3.4 Water Level (Flood) Design

The information in this section of the reference ABWR DCD, including all subsections and tables and figures, is incorporated by reference with the following supplements and departures.

Figure 3.4-1 Non-Breaking Wave Force on Vertical Wall

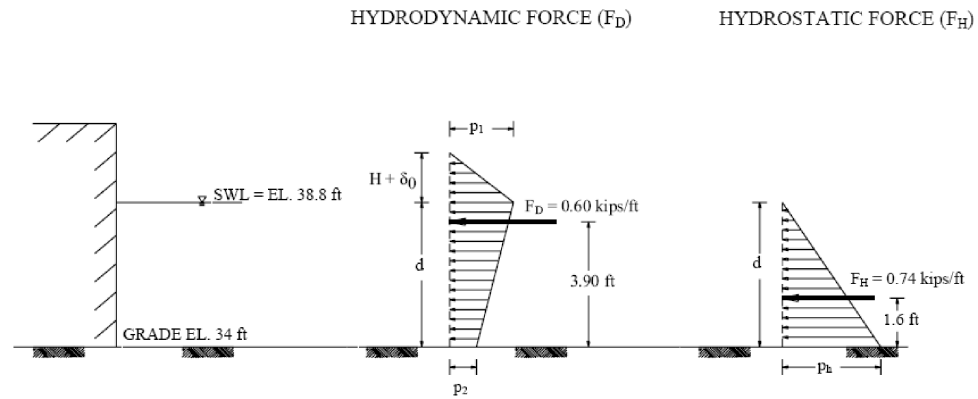
As discussed in Section 2.4S.4.2.2.4.3, the hydrodynamic force due to the wind-generated wave action on building walls has been calculated as shown in Figure 3.4-1.

- Wind generated wave forces as shown in Figure 3.4-1, applicable to above grade portion.
 - Impact due to a 500 lbs floating debris traveling at 4.72 ft/sec.

FL = Design basis extreme flood loads, including the hydrostatic load due to flood elevation at 40 ft MSL, the associated drag effects of 44 psf, impact due to floating debris per Section 3.4.2, and hydrodynamic load due to wind-generated wave action per Figure 3.4-1. Figure 3.4-1 shall only be used to calculate hydrodynamic load due to wind-generated wave action. The weight of the water (above ground) due to the flood loads shall be 63.85 pcf in order to include the effects of suspended sediments in the water.
